Application Note
Through-Beam-Sensors
with activation input

General Information

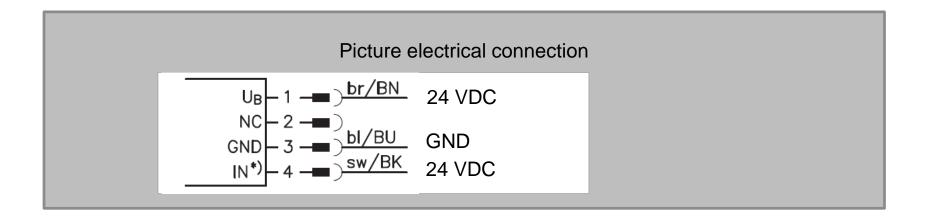
If you substitute only the transmitter or the receiver please only substitute the sensor with exactly the same part no.

If the original sensor is discontinued, please exchange the whole axis (transmitter and receiver).

The successor has an input for test-activation. The transmitter only emits light if the input is connected to 24V (see diagram for electrical connection).
